## Referee #2

Xu et al. compare the changes in aridity under a worst-case warming scenario (RCP8.5), an extreme mitigation and carbon dioxide removal scenario (that I'll refer to as CDR) and the GLENS sulphate aerosol injection scenario (that I'll refer to as GLENS). They combine results from 2 versions of the same base model (with importantly different climatologies) CESM1, which ran the CDR scenario, and WACCM, which ran the GLENS scenario, to assess the surface hydrological response to these different scenarios. To make the two ensembles comparable bias-correction is applied such that both models are adjusted to match the observed climatology.

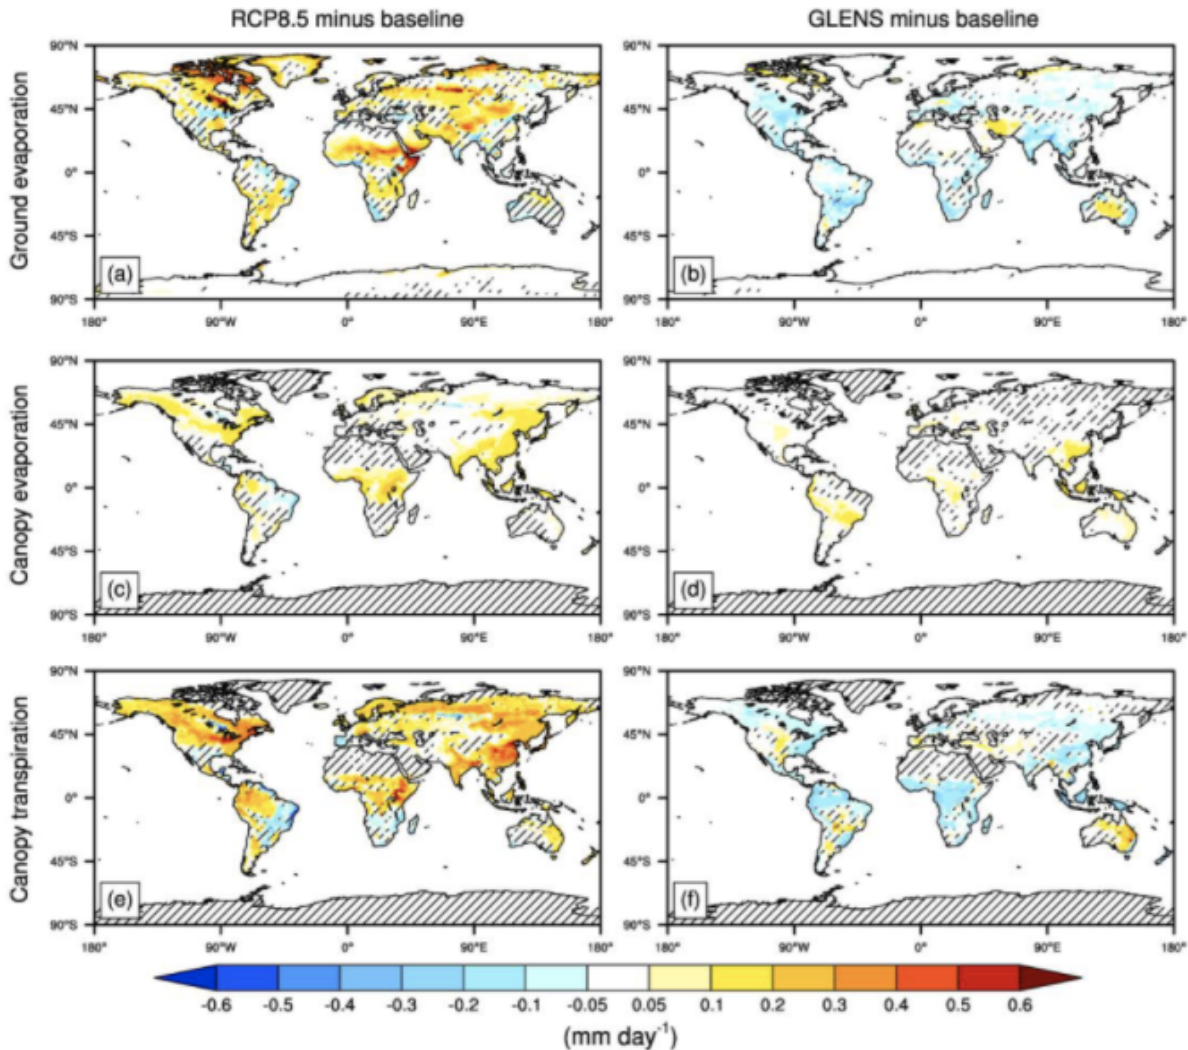
I was surprised that transpiration wasn’t discussed as this is a major driver of terrestrial hydrology. I strongly recommend considering the direct CO2 physiological effect of CO2 in these simulations as this will be a big difference between CDR and RCP8.5 / GLENS.

As for the calculation of PET, we formulate it as a function of temperature, relative humidity, available energy, wind, and bulk stomatal resistance (rs). We indeed employed a fixed bulk stomatal resistance (i.e., 70 s/m) while those values can vary over different regions and time as the reviewer suggested.

The simplification is justified by that even adopting widely different but reasonable choices of vegetation parameters including rs, the PET values do not change much (within 5%). Scheff and Frierson (2014), Fu and Feng (2014) and Fu et al., (2016) showed:

Note that the magnitude of the PET relative change is largest when rs=0, then it goes down to be less than -0.4%/ (s/m). The negative sign means that, with elevated CO2 level, a larger stomatal resistance leads to smaller PET (implying a terrestrial wetting if everything else is fixed).

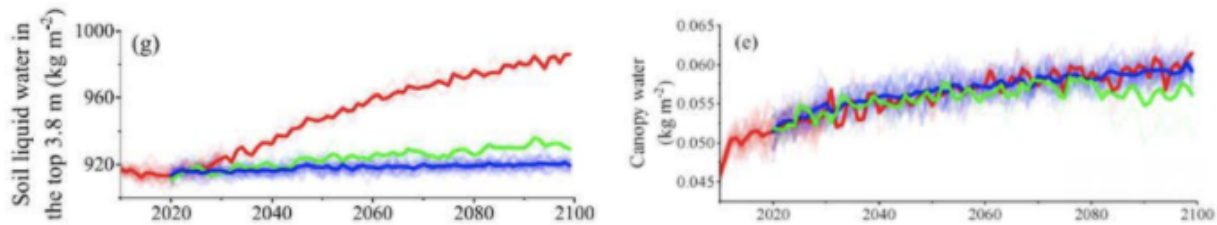
The authors report results showing PET and ET over land, finding that they both increase in lockstep. This was surprising to me, given the results of Swann et al. (2018) who found that PET was projected to increase in models while ET was not. Swann et al. found that this was due to reductions in transpiration due to CO<sub>2</sub> fertilization offsetting the meteorological drivers that drove PET increases. This suggests that the CO<sub>2</sub> physiological effect has not been included or is very weak. Please provide details and analysis to address this.

This refers to Fig 1(a). ET increase in WACCM simulation but note that ET increase is 100 mm/year less than increase in PET). The ET increase is also consistent with decrease in soil water in top 10 cm of soil.

But, Why an increase in ET? Cheng et al. (2019), co-author of the present study, has looked into that carefully and found that global mean ET is indeed increasing including the canopy transpiration part under RCP8.5. We also checked distribution of canopy transpiration (Bottom row in the next figure), with increase in most land area under RCP8.5, except Southeast Brazil and Southern Africa.

As speculated by the reviewer, in these two models, increases in soil liquid water and canopy intercepted water under RC8.5 (red lines in the next figure) overwhelms the direct physiological effect of CO<sub>2</sub> (suppressing transpiration) in RCP8.5.

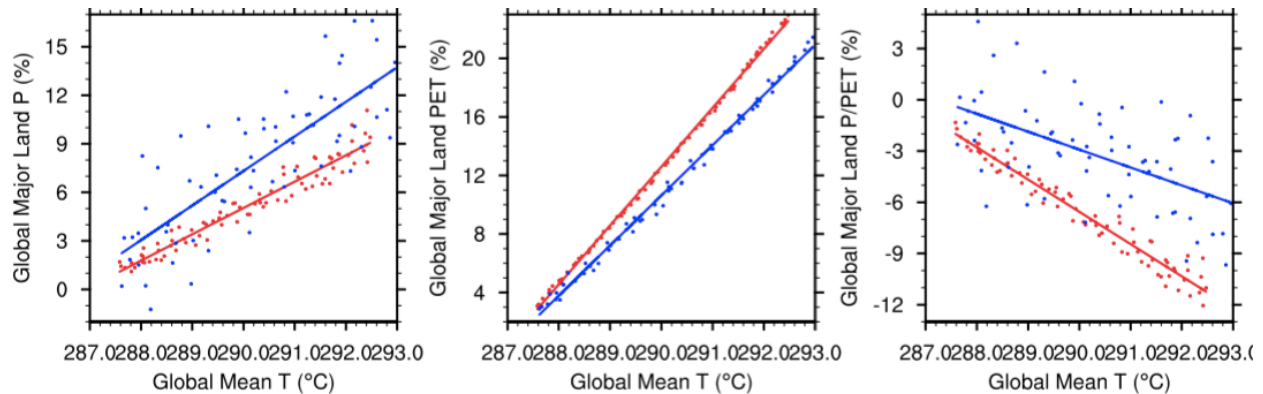
I'd suggest producing a similar plot for the RCP8.5 results of the 2 model versions as I suspect that they could look quite different and this might be driving some of the difference attributed to the forcing differences here.

**We plot the RCP8.5 results as suggested. There are some differences between two models, so we agree with the reviewer that model difference is partially contaminating the normalized results. We have fully acknowledged this caveat in Section 5 and also in the conclusion section and called for future research to systematically address this issue (hopefully using multiple models).**
